**BEFORE
THE OHIO POWER SITING BOARD**

In the Matter of the Application of	)	
Kingwood Solar I LLC for a Certificate	)	Case No. 21-0117-EL-BGN
of Environmental Compatibility and	)	
Public Need	)

**KINGWOOD SOLAR'S JUNE 1, 2021 RESPONSES
TO STAFF'S MAY 17 AND MAY 20 DATA REQUESTS**

Figure DR1-1
 Project Area Delineated Stream Segments
 Kingwood Solar
 Greene County, Ohio

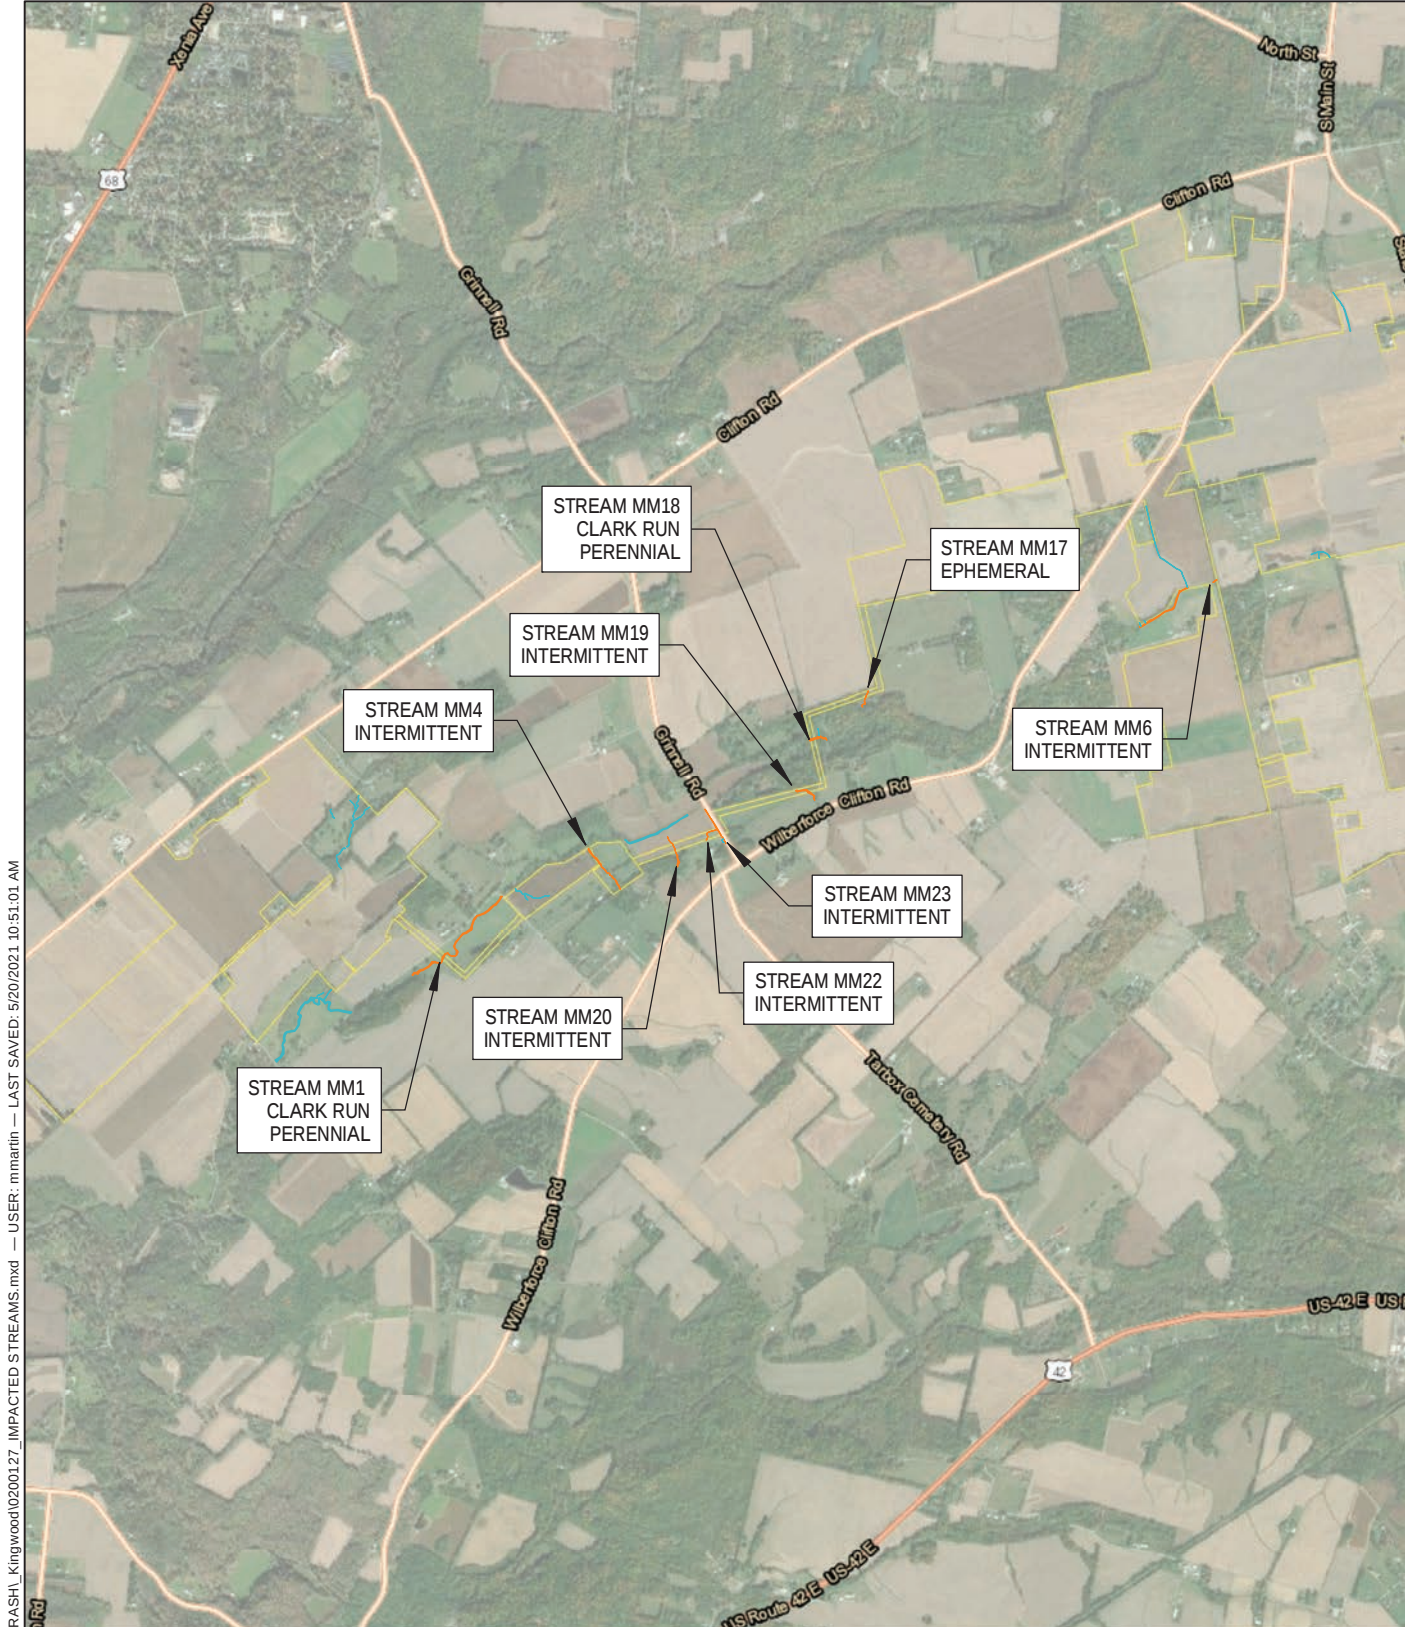
1. *Haley and Aldrich delineated a total of 6 wetlands and 27 streams within the project area. What are the estimated totals of temporary and permanent impacts to streams and wetlands for construction of the Project? Please also provide a detailing of which streams and wetlands are to be impacted by project construction? (Example: Wetland MMD and Stream MM8 will be impacted via a culvert crossing, etc.)*

Six wetlands were identified. No wetland impact is proposed for the Project. A total of 27 stream segments were identified. Four of these reflect different segments of Clark Run as it traverses portions of the Project Area; the remaining 23 stream segments reflect portions of different streams that traverse portions of the Project Area. Therefore, 24 streams occur within the Project Area.

A total of 9 stream segments will be crossed by underground collection lines. All collector line impacts will be temporary impacts. Therefore, no permanent impacts to streams or wetlands are proposed.

Figure DR1-1 provides a map illustrating the location of delineated streams within the Project Area and locations where collector line impact is proposed. Table 1 provides additional detail regarding anticipated potential impact, conservatively assuming the use of open trench techniques, which will be confirmed based on final engineering design; where HDD or similar techniques will be used, stream impact would be eliminated. Note that individual stream impacts under 0.1 acre (as is the case for all locations where impacts could occur) do not require a pre-construction notification in order to qualify for coverage under the United States Army Corps of Engineers Nationwide Permit 57. At the state level, stream impacts are also assessed in individual locations, with impacts less than 500 linear feet (as is the case for all locations where impacts could occur) not requiring a permit from Ohio EPA.

Figure 04-1
Solar Resource Map of Ohio
Kingwood Solar
Greene County, Ohio

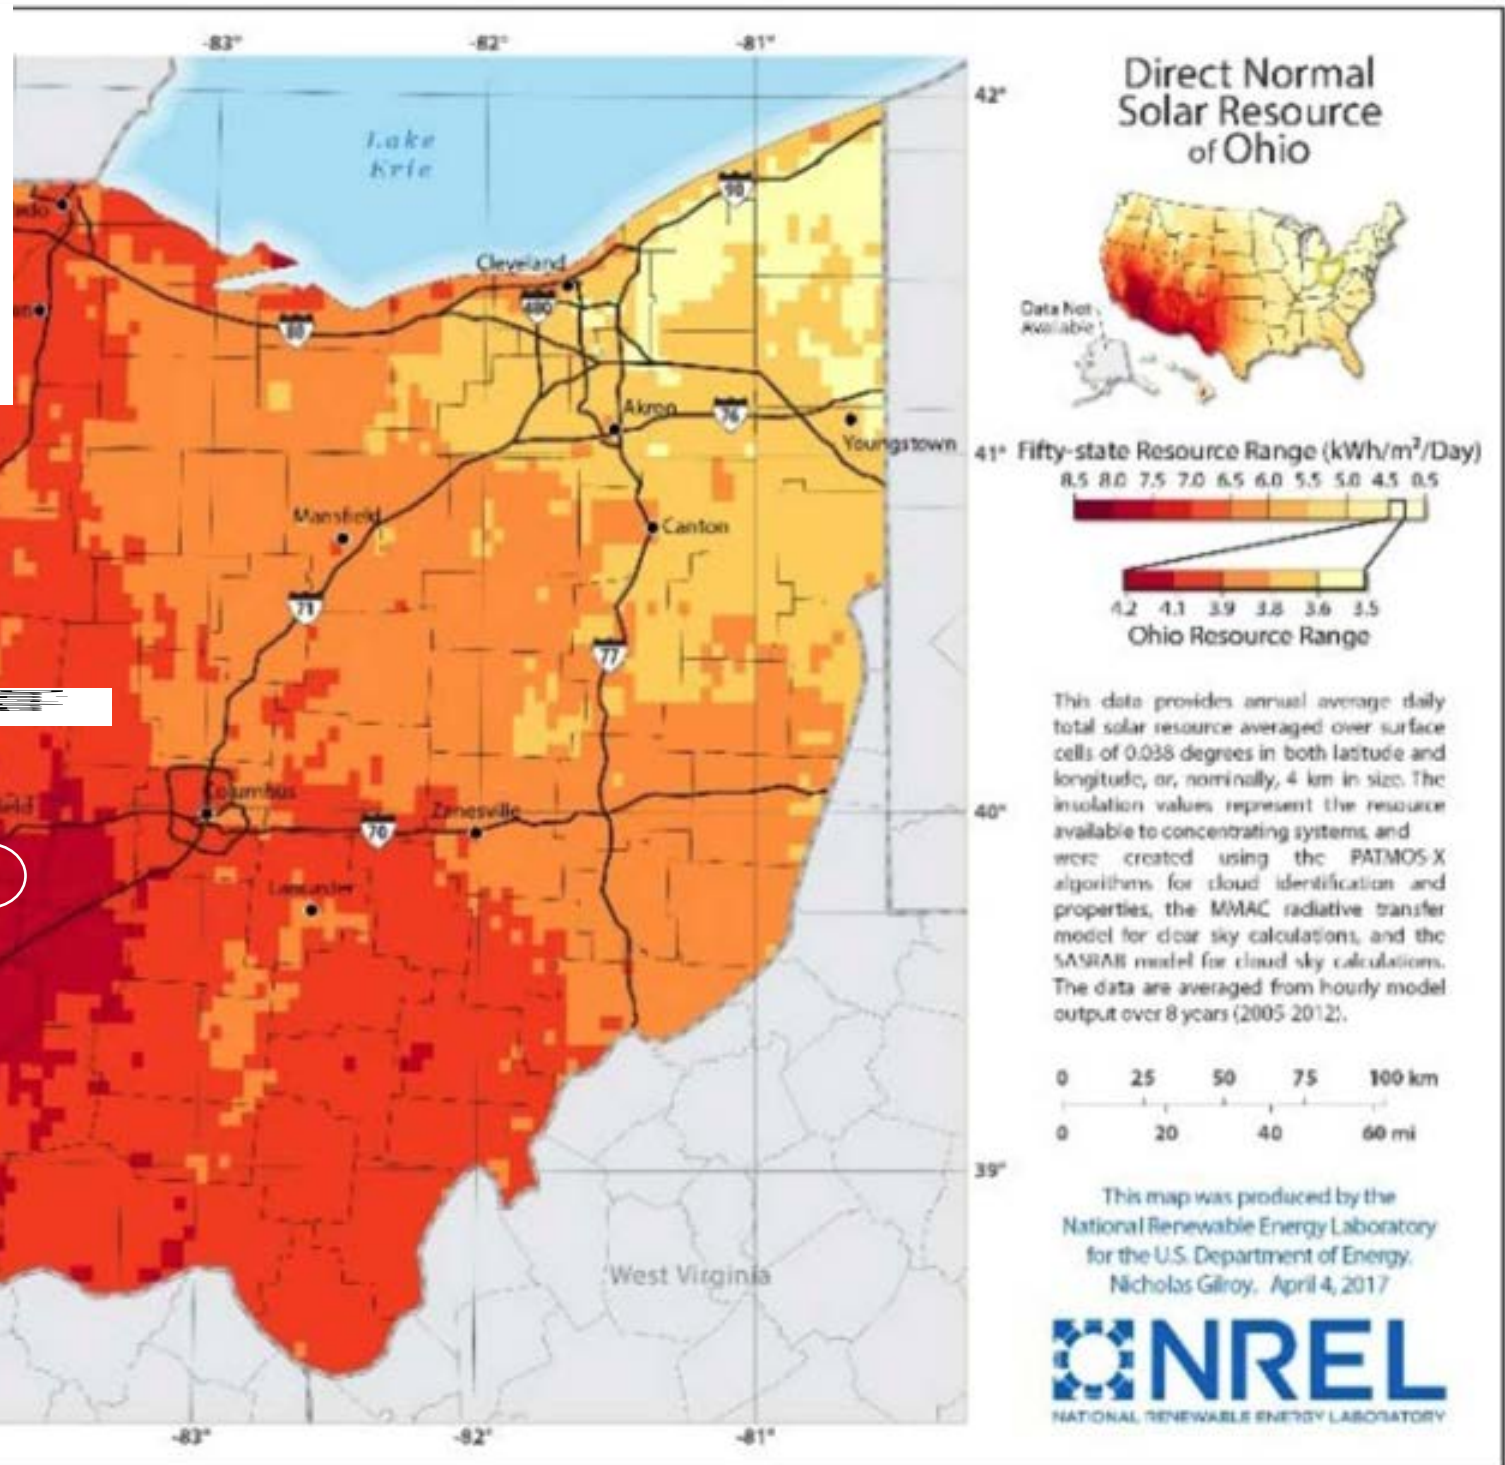
12. The electronic version of Figure 04-1 filed in the PUCO docketing information system is difficult to read. Please provide a clean and easy to read version of Figure 04-1.

A revised copy of Figure 04-1 is attached. As shown, the Project Area is located in the southwestern portion of Ohio, which receives the most direct solar resources within the state.
